95 BERKELEY

SELDC | OCTOBER 1, 2024

WHAT WE HEARD

BERKELEY ST

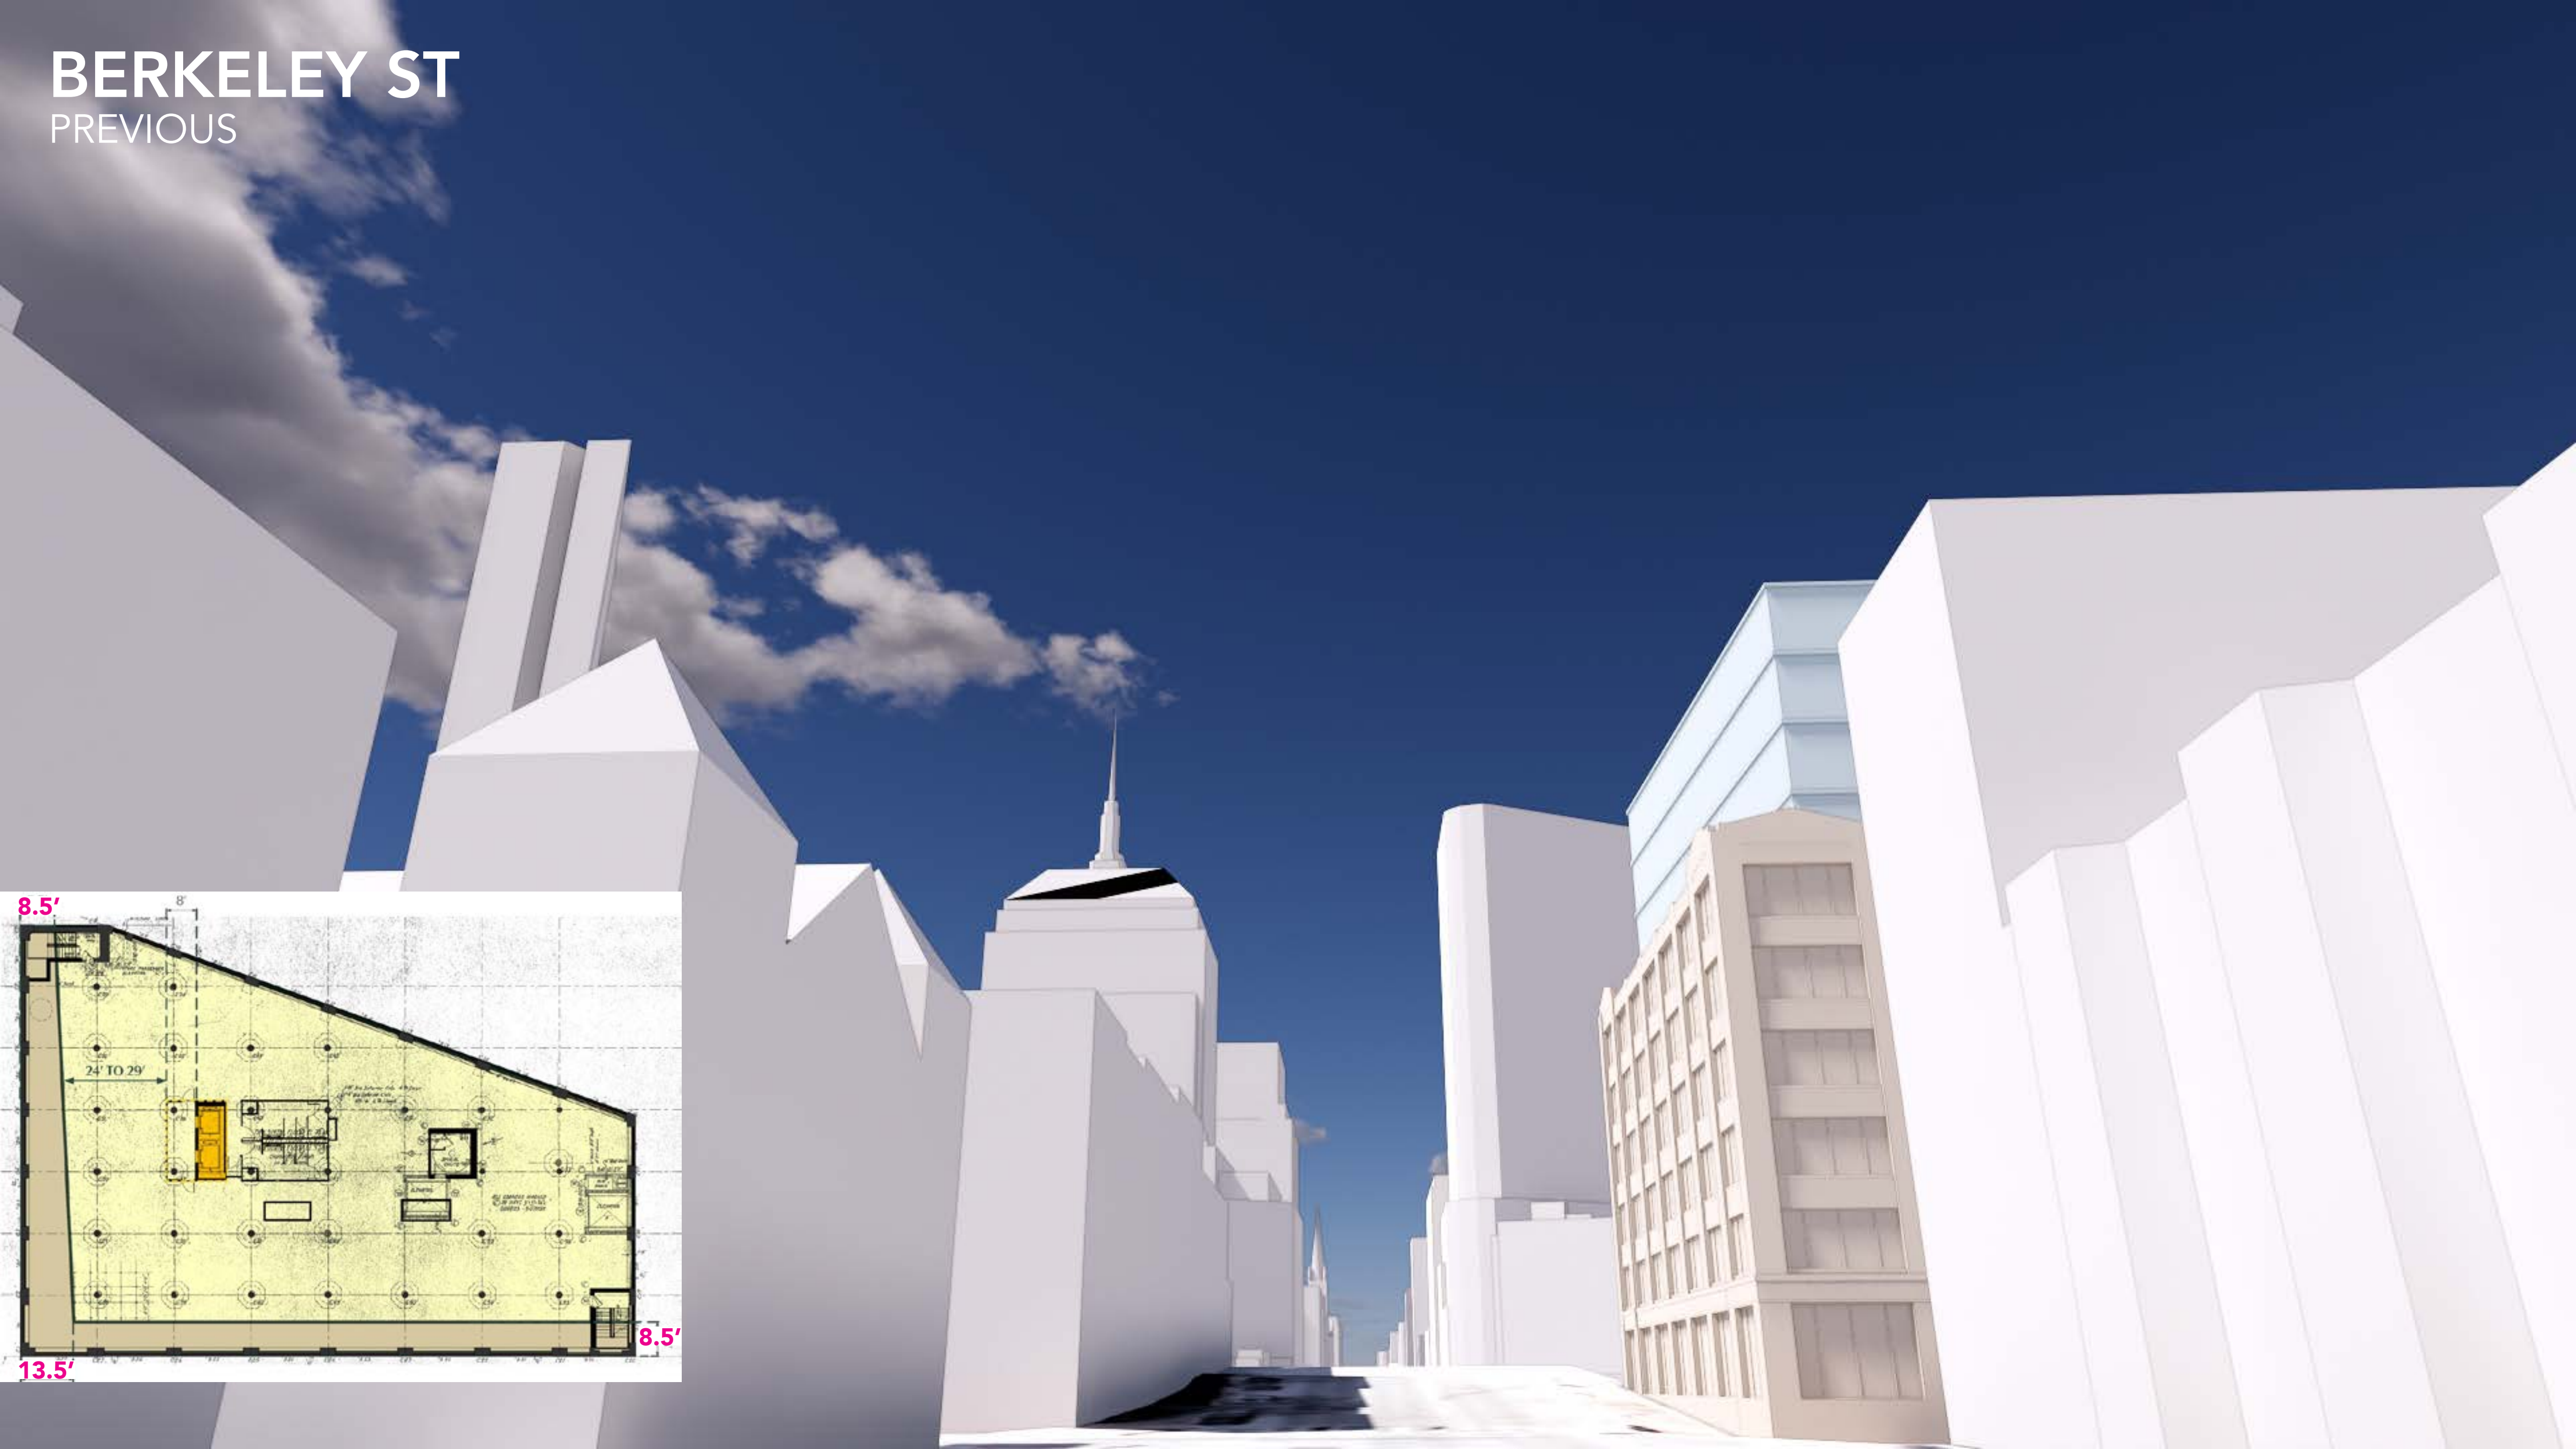
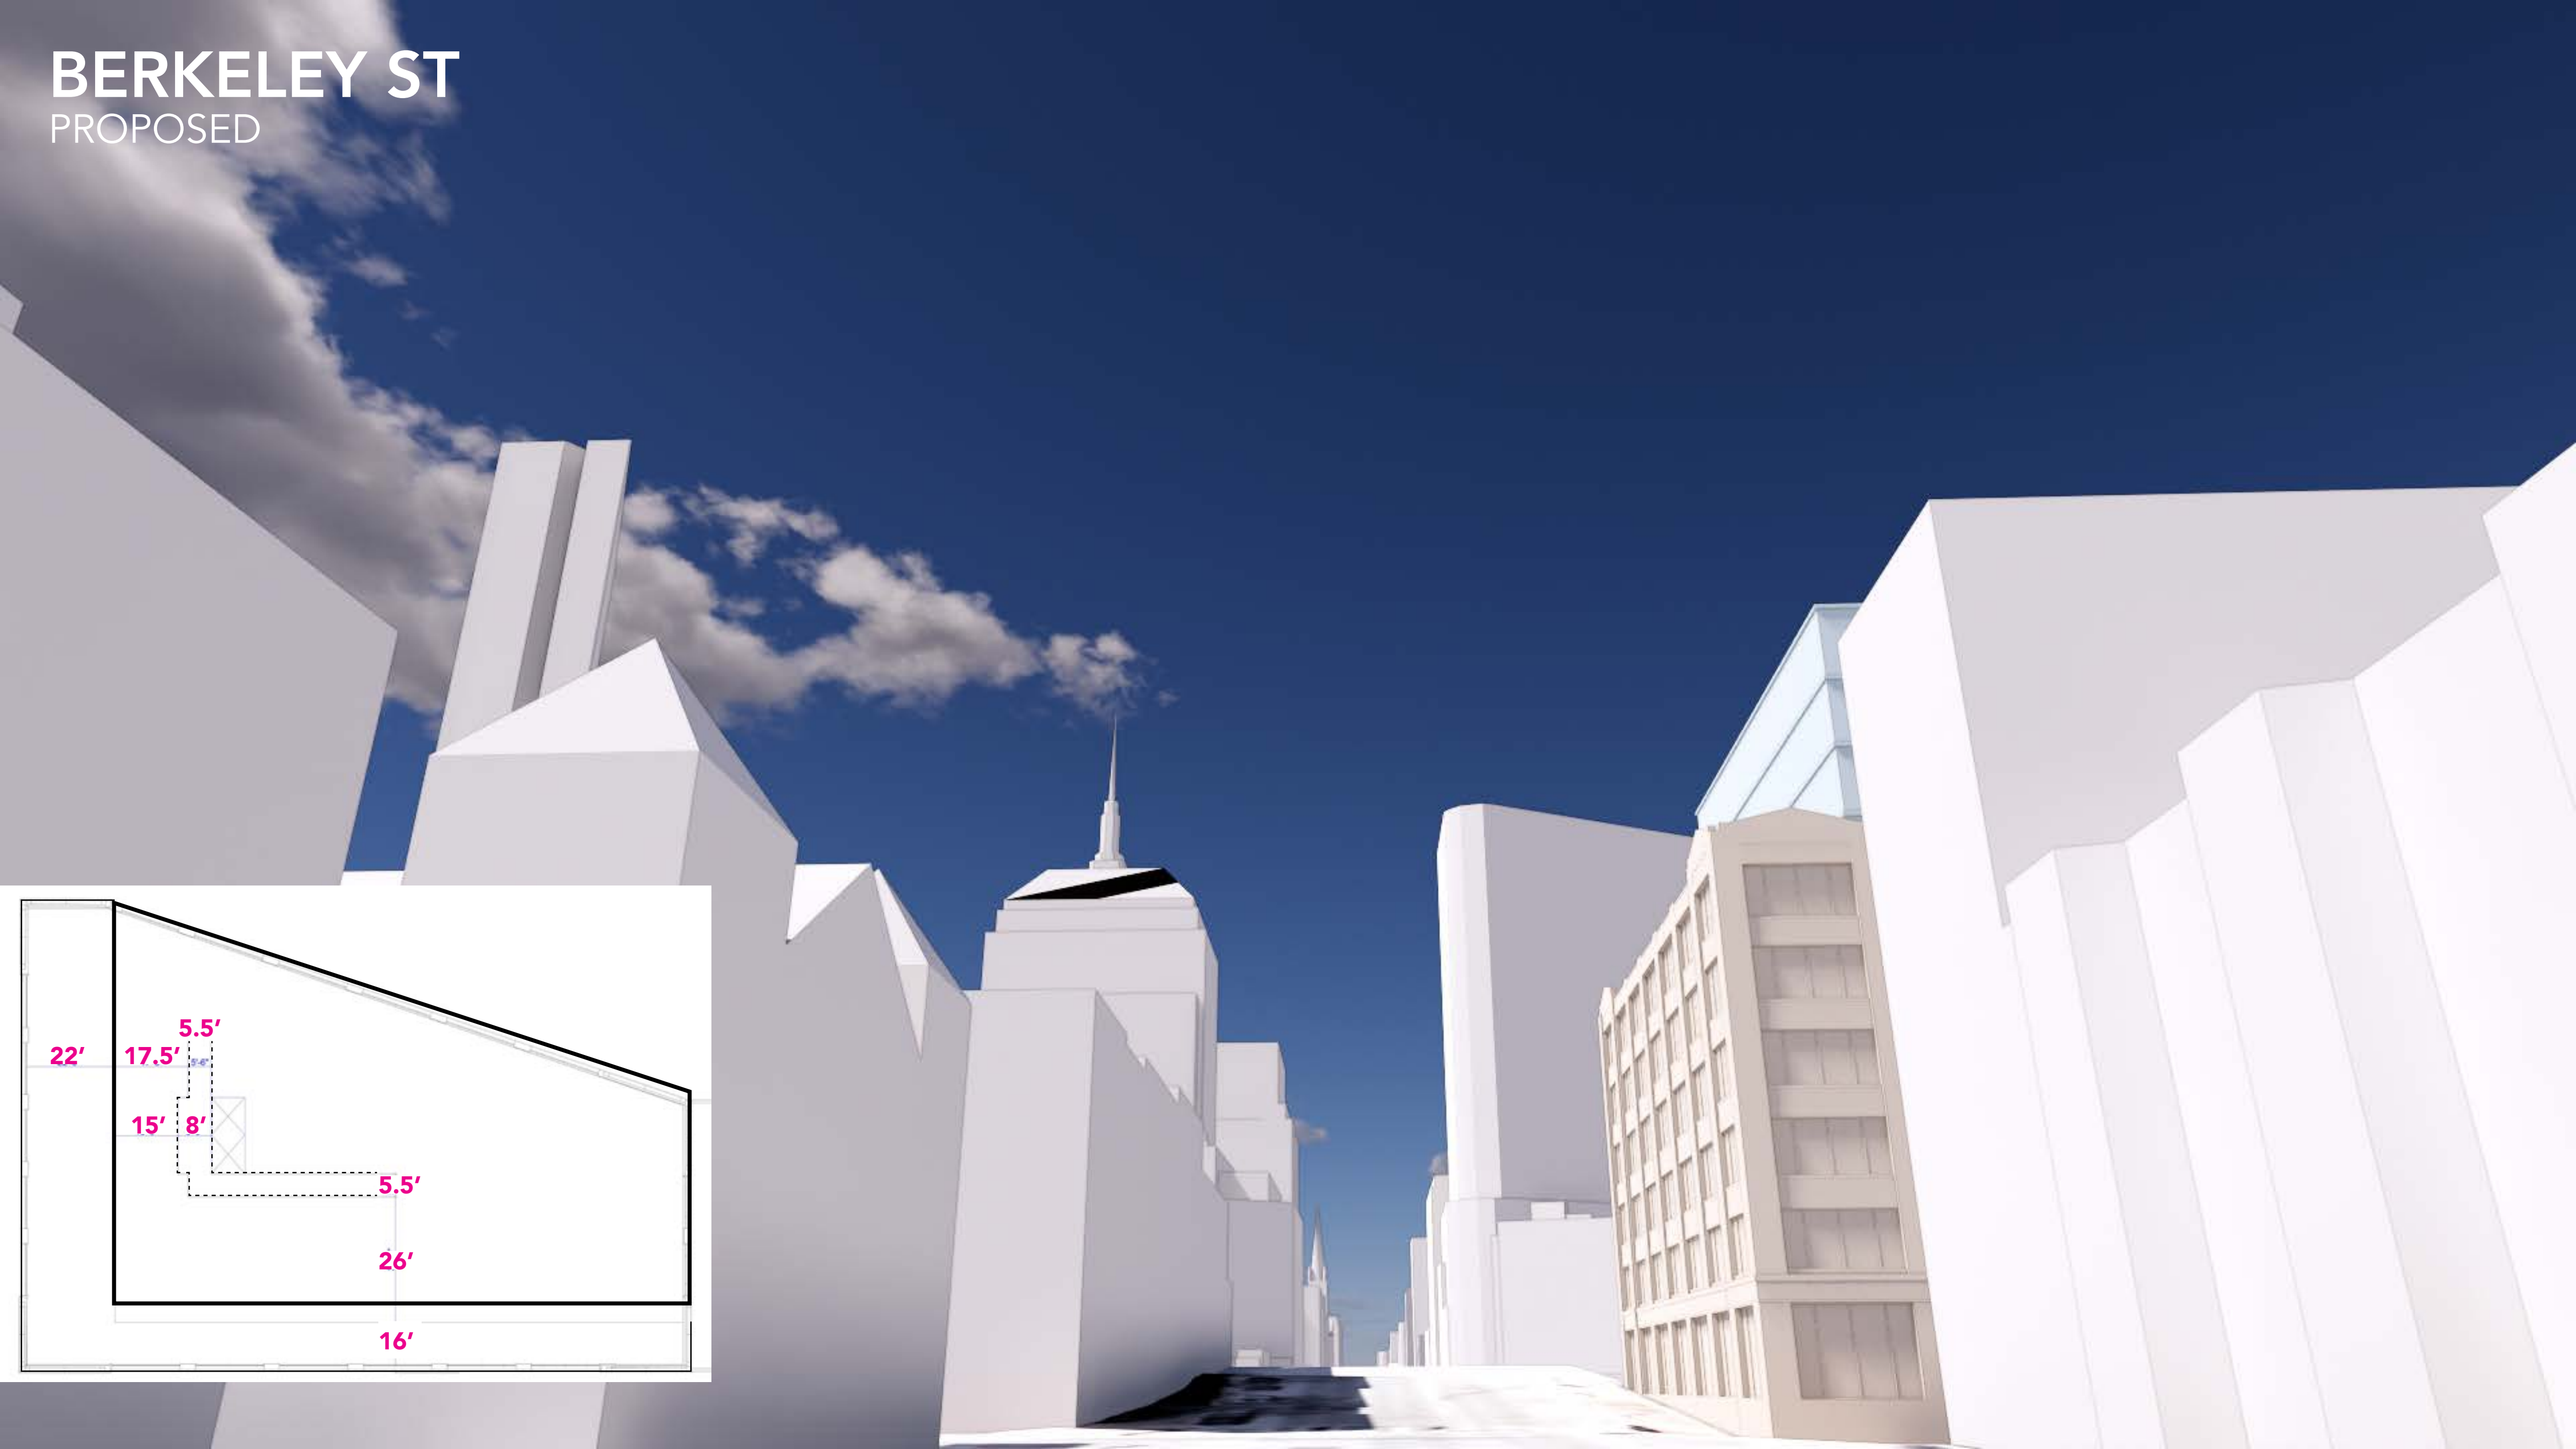
02 Avoid corner cornices when viewed from Berkeley
